# Metropolitan Development Commission Regional Center Hearing Examiner (April 23, 2026) Meeting Agenda

# STAFF REPORT

## REGIONAL CENTER HEARING EXAMINER - HIGH IMPACT CASE

<b>Case Number</b>	2026-REG-029
<b>Address (approx.)</b>	1140 Dr. Martin Luther King, Jr. Street
<b>Location</b>	Center Township, Council District 12
<b>Petitioner</b>	Indianapolis Public Schools, by Russell McClure
<b>Zoning</b>	SU-2 (RC)
<b>Request</b>	Regional Center Approval to provide for a proposed multi-purpose building for health and wellness, including a gymnasium, and for two bleacher structures to accommodate up to 2,000 persons at an outdoor recreational facility, plus an outdoor educational and public amenity space.

Planting Schedule & Details

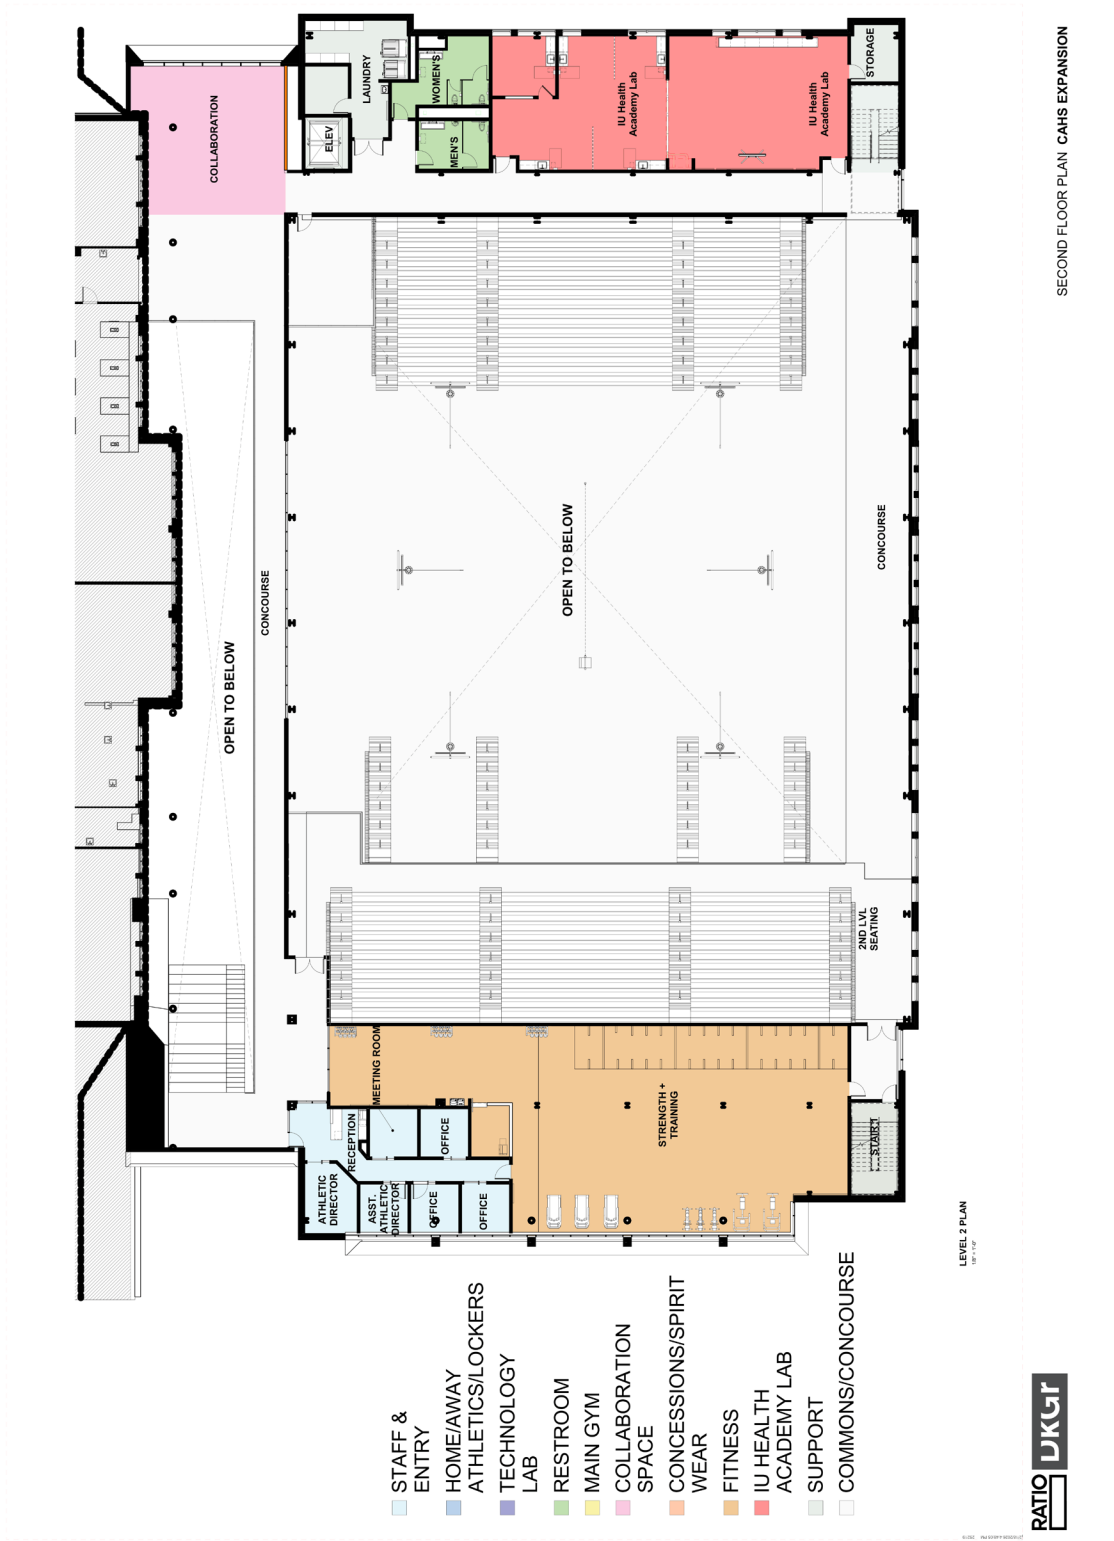
2. The landscaping plan submitted to the file did not include calculations to review for compliance with the landscaping standards outlined in Chapter 744. Article V of the Zoning Ordinance, including interior parking lot landscaping. *An updated landscaping plan for the site with the relevant calculations shall be submitted and subject to planning staff review and approval, prior to the issuance of an Improvement Location Permit.*
